# Access Compliance Report

## Public Rights-of-Way

### (Curb Ramps)

Intersection ID: 18573	Main Street: PLEASANT_DR	Cross Street: WHEELER_DR	Location: E
ADA ID: 6784A73C06CB	Ramp Type: PerpDiag	Initial Pass/Fail: Fail	Overall Compliance: No
		Severity Score: 12.5

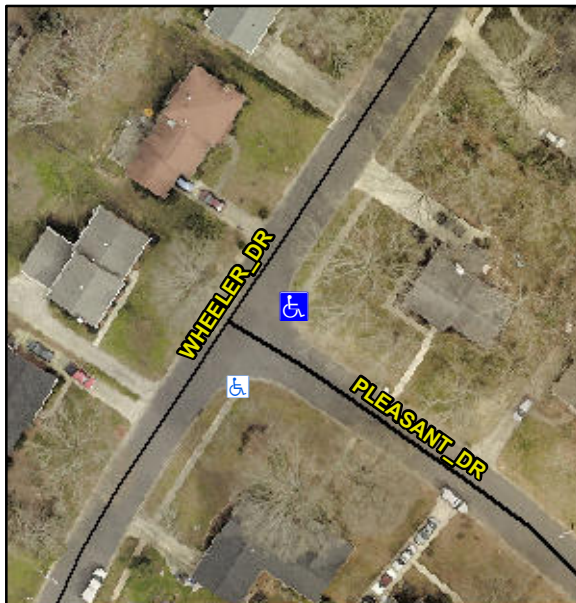
**Not Found, R304.2.2**

Compliance	Description	Data	Compliance	Description	Data
N/A	Ramp Length (in)	30.0	No	Ramp Slope (%)	9.2
Yes	Ramp Width (in)	48.0	Yes	Ramp XSlope (%)	0.0
N/A	Flare Type LT	N/A	N/A	Flare Type RT	N/A
N/A	Flare Slope LT (%)	N/A	N/A	Flare Slope RT (%)	N/A
N/A	Flare Traversable LT?	N/A	N/A	Flare Traversable RT?	N/A
N/A	Landing Length (in)	N/A	N/A	DWS Provided?	N/A
N/A	Landing Width (in)	N/A	N/A	DWS Contrast?	N/A
N/A	Landing Slope (%)	N/A	N/A	DWS Length (in)	N/A
N/A	Landing X Slope (%)	N/A	N/A	DWS Full Width?	N/A
N/A	Landing Curb? (Y/N)	N/A	N/A	DWS Offset (in)	N/A
N/A	Shared Landing?	N/A			
N/A	Gutter Ponding?	N/A	N/A	Gutter Slope (%)	N/A
N/A	Gutter Lip Ht (in)	N/A	N/A	Gutter X Slope (%)	N/A
N/A	Painted X Walk1?	No	N/A	Painted X Walk2?	No
	X Walk 1 Direction	To NW		X Walk 2 Direction	To SW
N/A	X Walk 1 Width (in)	N/A	N/A	X Walk 2 Width (in)	N/A
	X Walk 1 Slope (%)	3.0		X Walk 2 Slope (%)	1.9
	X Walk 1 X Slope (%)	3.1		X Walk 2 X Slope (%)	2.8

**Remove & Replace Curb Ramp With Two New Directional Ramps or Equivalent.**
